## Author comment on

Sihler, H., Platt, U., Beirle, S., Marbach, T., Kühl, S., Dörner, S., Verschaeve, J., Frieß, U., Pöhler, D., Vogel, L., Sander, R., and Wagner, T.: Tropospheric BrO column densities in the Arctic from satellite: retrieval and comparison to ground-based measurements, *Atmos. Meas. Tech. Discuss.*, 5, 3199-3270, doi:10.5194/amtd-5-3199-2012, 2012.

new Fig. 1b

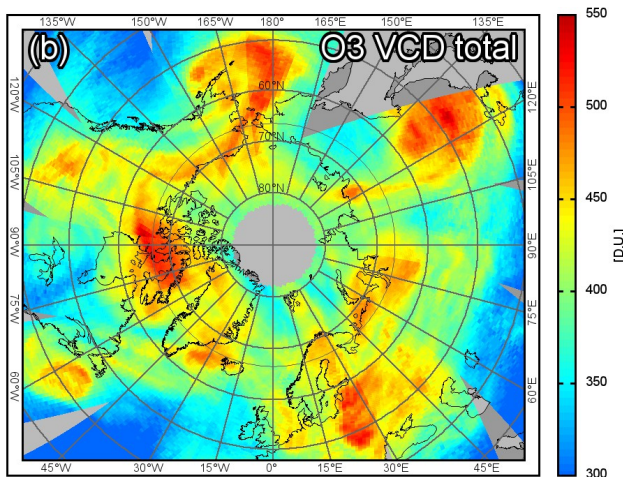
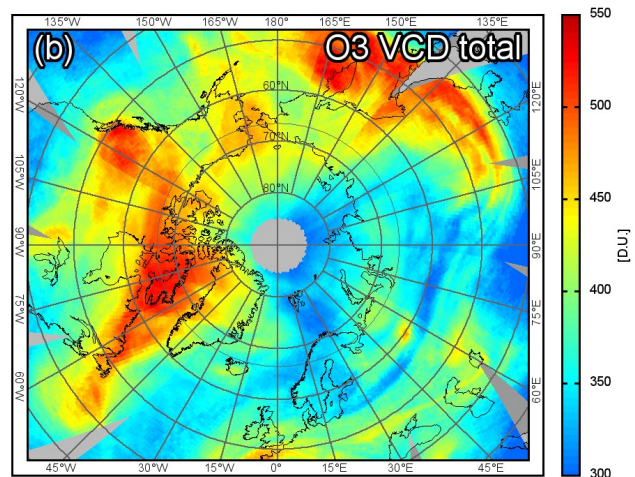
R1C: - Fig1b. It would be better to express the O3 VC in Dobson units (the most used unit).

AC: The authors would like to follow this suggestion and replaced Figs. 1b and 2b with the following plots expressed in dobson unit (D.U.), respectively.

It needs to be noted that the retrieval presented in this paper has not been optimised for the quantitative retrieval of the O3 column and, hence, the above figures are potentially biased, especially because no adequate AMF from RTM is used. This bias, however, will cancel in the retrieval as long as the O<sub>3</sub> SCD retrieved from analysing the GOME-2 spectra are linearly correlated to the real O<sub>3</sub> SCD.

As the BrO/O<sub>3</sub>-ratio is furthermore expressed dimensionless, the following sentence needs to be appended to Eq. (4) in the new manuscript:

"[...] (4) [line break] where  $S_{\text{strat},\text{O}_3}$  is expressed in molec cm<sup>-2</sup> using the definition of the Dobson unit ( $1\text{DU}=2.69\times 10^{16}$  molec cm<sup>-2</sup>)."  
(p. 3207, l. 15)
